NRC/DOE Technical Exchange on Yucca Mountain Pre-Licensing Issues

April 25-26, 2000

TECHNICAL EXCHANGE ON YUCCA MOUNTAIN PRE-LICENSING ISSUES April 25 - 26, 2000 at Las Vegas, NV

PURPOSE AND OBJECTIVE: To review the status, discuss and document the path forward for resolution of NRC Key Technical Issues; discuss role of Key Technical Issues in Sufficiency.

Subissue 5: Saturated Zone and Dilution

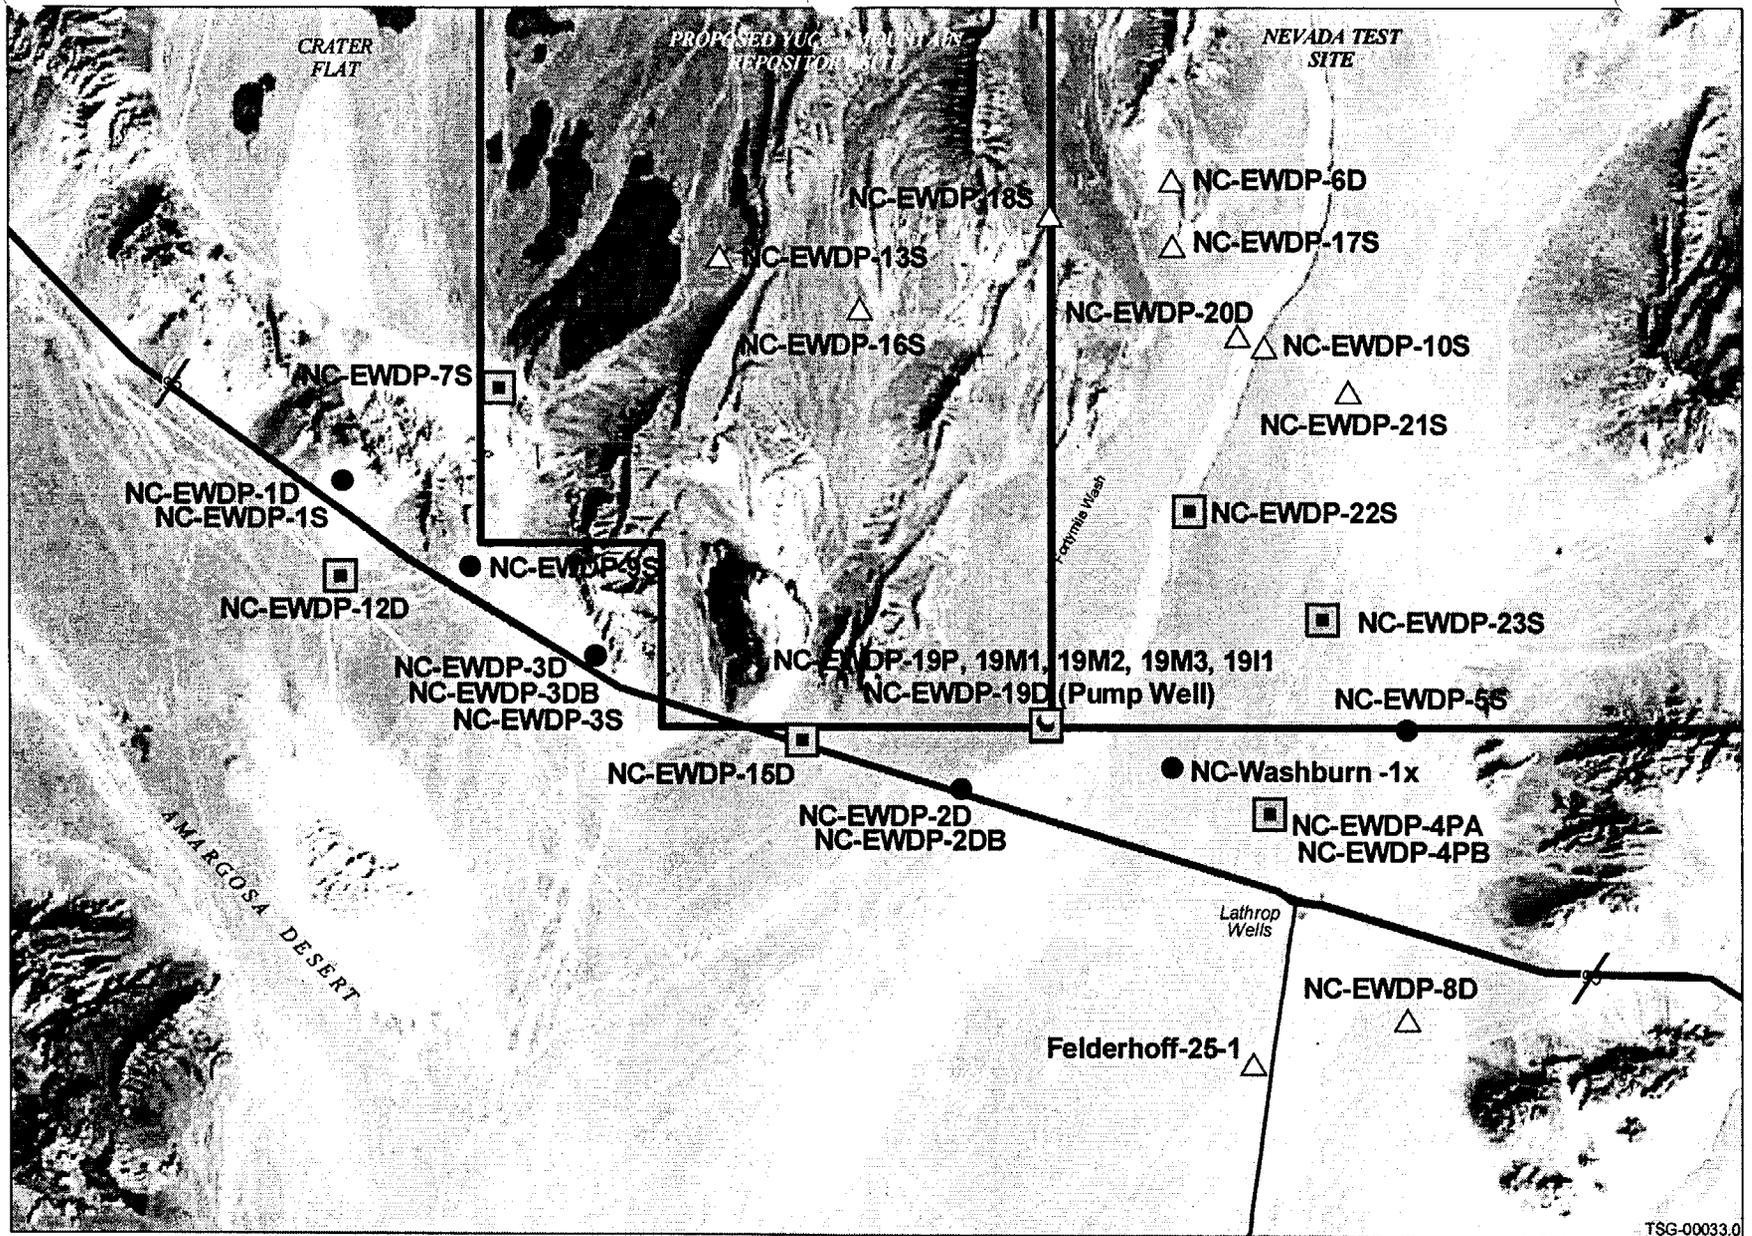
Properties of the SZ (especially alluvium) have a large effect on performance, and compliance must be shown at downgradient locations where groundwater is pumped from the SZ

- **Show where the water table transitions from the tuffs to valley fill, or conservatively use the shortest lengths of alluvial transport paths that can be justified**
- **Provide and analyze data from the C-holes, SD-6, and WT-24; obtain hydraulic conductivity & effective porosity for saturated valley fill at 20-km and in data gaps to the south; performance seems more sensitive to properties of alluvial flowpaths than to those of tuffs**
- **Do C-14 dating of organic carbon in groundwater from the SZ to estimate residence times (independent check on regional flow models)**

Thermal-Mechanical Effects on Design of Underground Facility

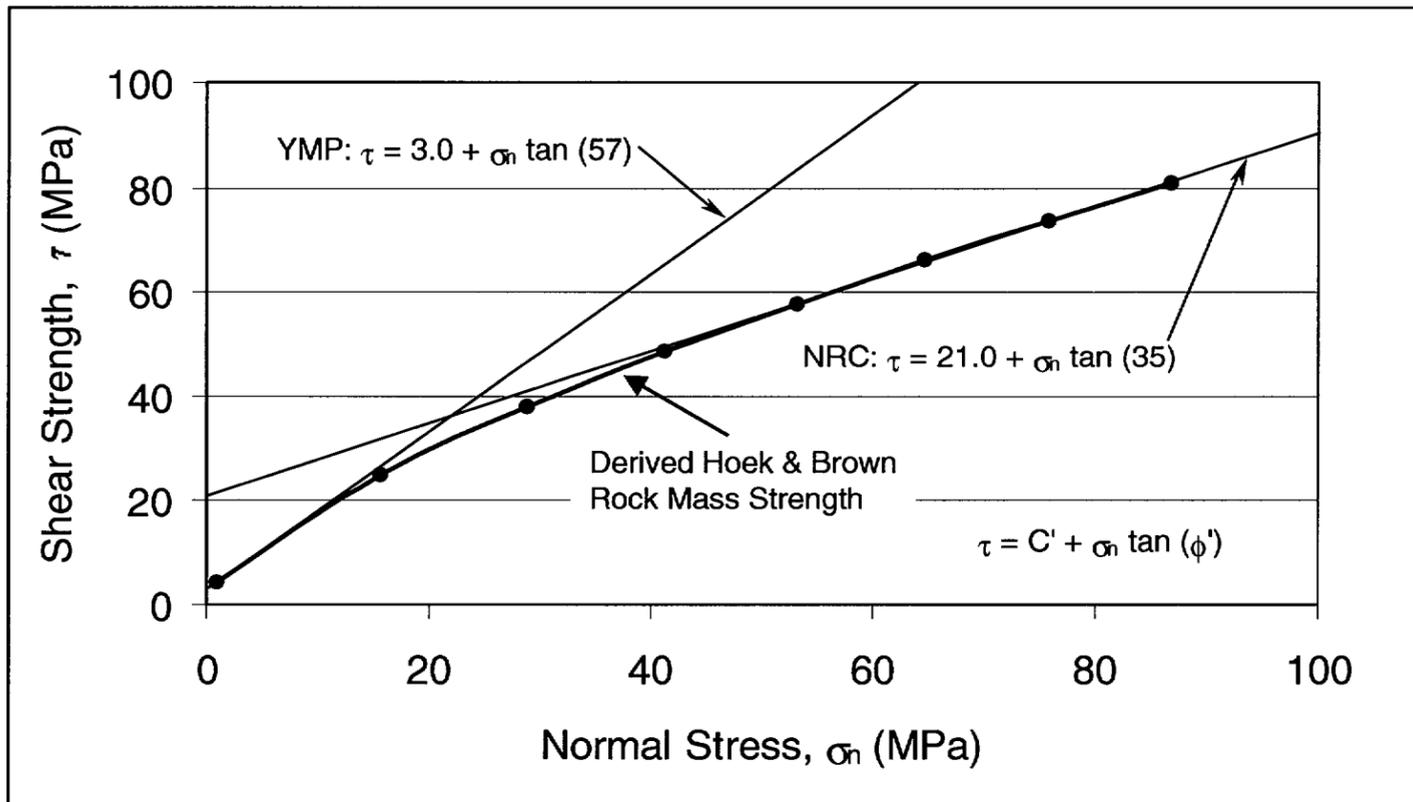
- Divergence of opinion related to predicted rock mass friction angles (IRSR, Section 4.3.3.2)
- DOE estimated rock mass properties based on geotechnical mapping of the rock mass following guidelines described by Hoek and Brown
- IRSR reports discrepancy in rock mass friction angles
 - DOE values: 57° to 58°
 - NRC values: 28° to 35°

Subissue 3: Does the DOE TSPA Adequately Account for Thermal Effects on Flow?

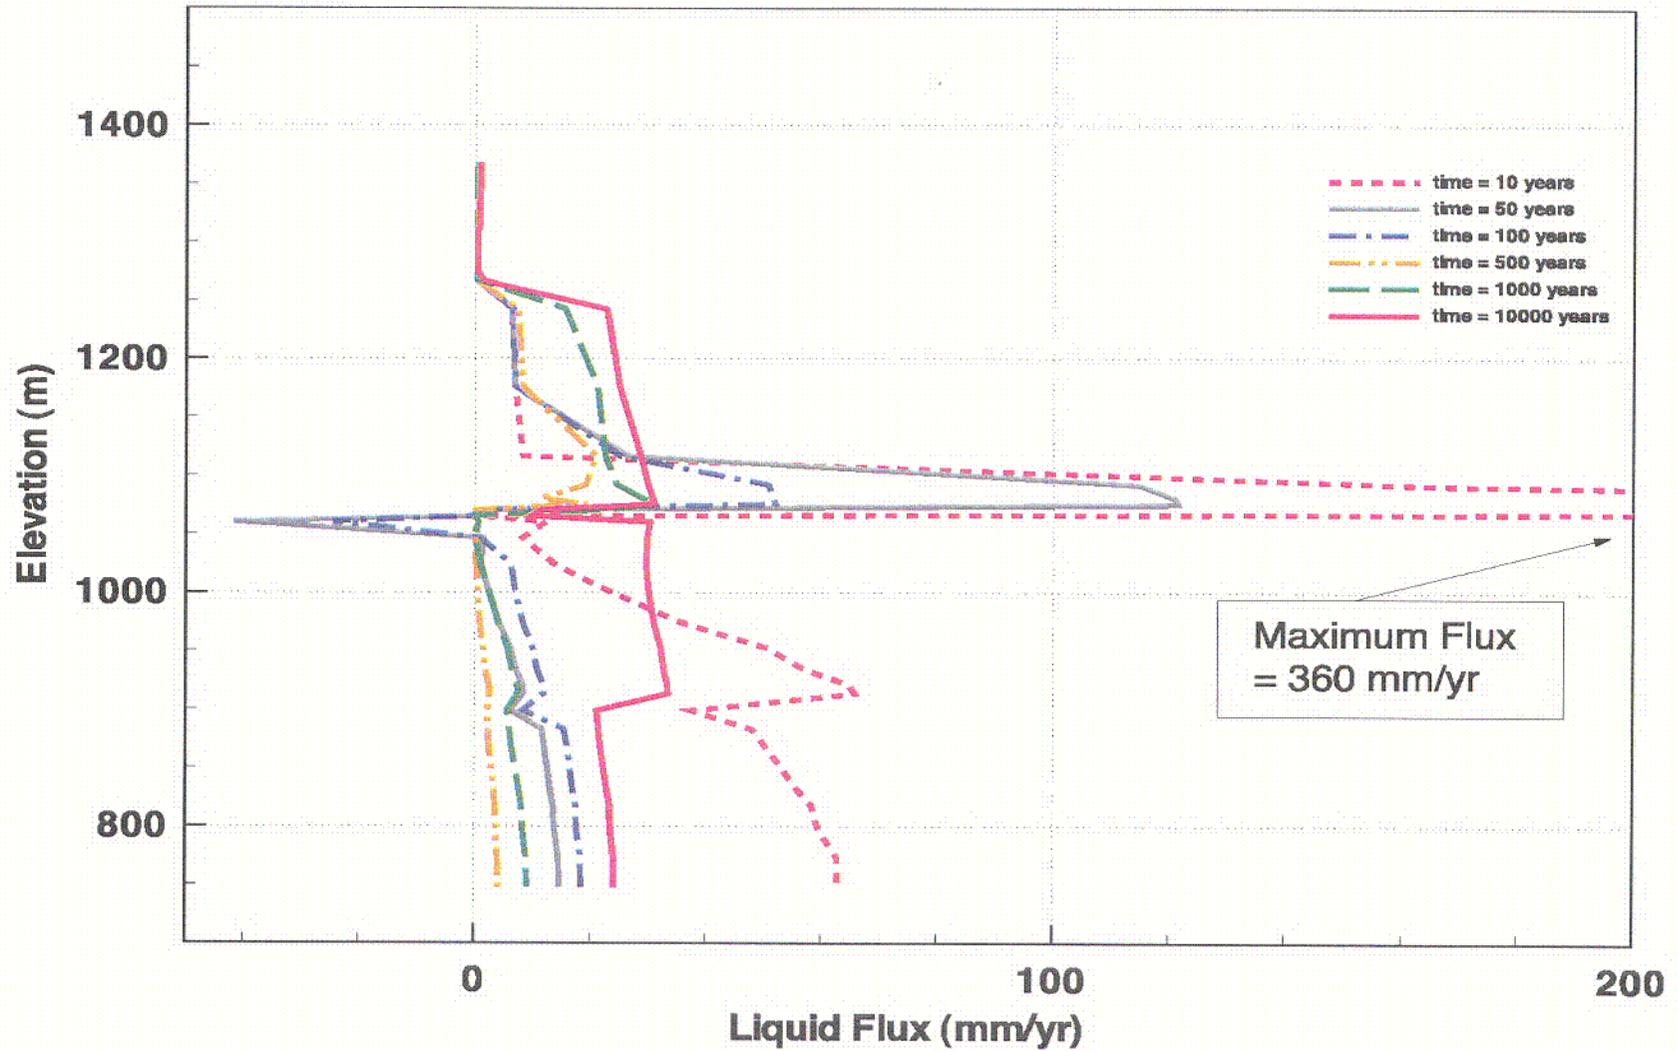
- **NRC considers issues open as a result of the heat and mass transfer issue in the Drift Scale Test**
- **Issue Resolution Status Report (IRSR) states that DOE has not yet demonstrated that the abstracted models used to bound process-level models, which predict water influx into an emplacement drift, are conservative**
- **IRSR states that process-level models do not yet incorporate all potentially important heat and mass transfer mechanisms**
